Parts Bulletin

Group	Number	Version
P-23-3	2	01

New Fuel Pump as Spare Part

Models: 2001, 2002, 2003, MD1, MD2, MD3, MDS, MD6, MD7, MD11, MD17, AQ2B

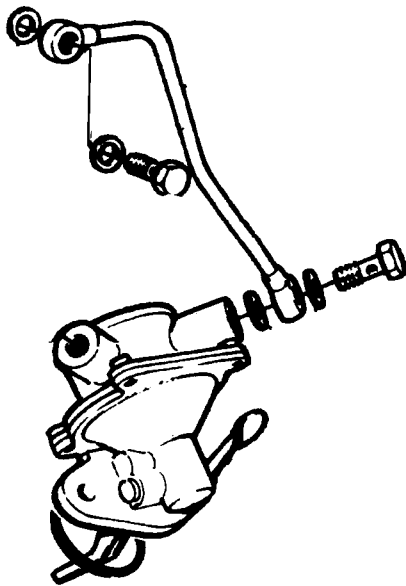
Fuel pump 833323 is obsoleted.

A new solution is produced. This demands a modification when it comes to outgoing fuel pipe.

This is a steel pipe and it is not possible to attach to the new fuel pump. In order to mount this pump you need to replace outgoing steel fuel pipe with hose part No 840001.

In short - 833323 is replaced by fuel feed pump 21134777 and hose 840001.
